Kilkenny County Council

Proposed IDA Belview Infrastructure Development at Belview, Slieverue

An Coimisiún Pleanála Case: ACP-324383-26

Submission Response

Figure 1-1: Existing UÉ Assets Map

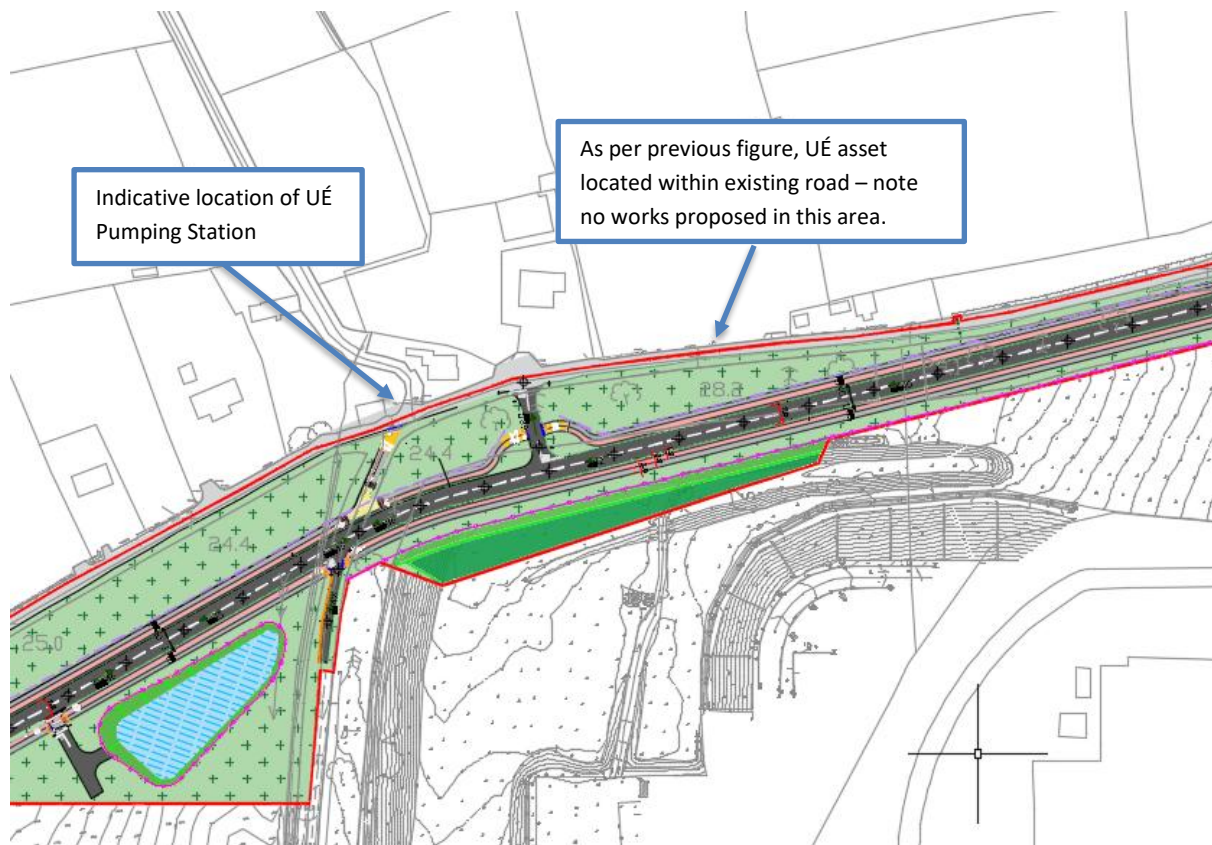
Item 5: Existing Uisce Éireann Assets

The infrastructure in question is not impacted by the proposed road as the proposed road alignment runs to the south of the existing UÉ asset – please refer to the Figures below identifying same –

Notwithstanding this feasibility confirmation, a formal build-over/diversion enquiry shall be submitted to Uisce Éireann Diversions Section (diversions@water.ie) in respect of the Belview No. 3 WWPS and 225 mm sewer; separation distances from public infrastructure shall be confirmed in the detailed design in accordance with Uisce Éireann Standards & Codes of Practice, and written Confirmation of Feasibility (COF) to build over or near assets shall be obtained prior to commencement of works.
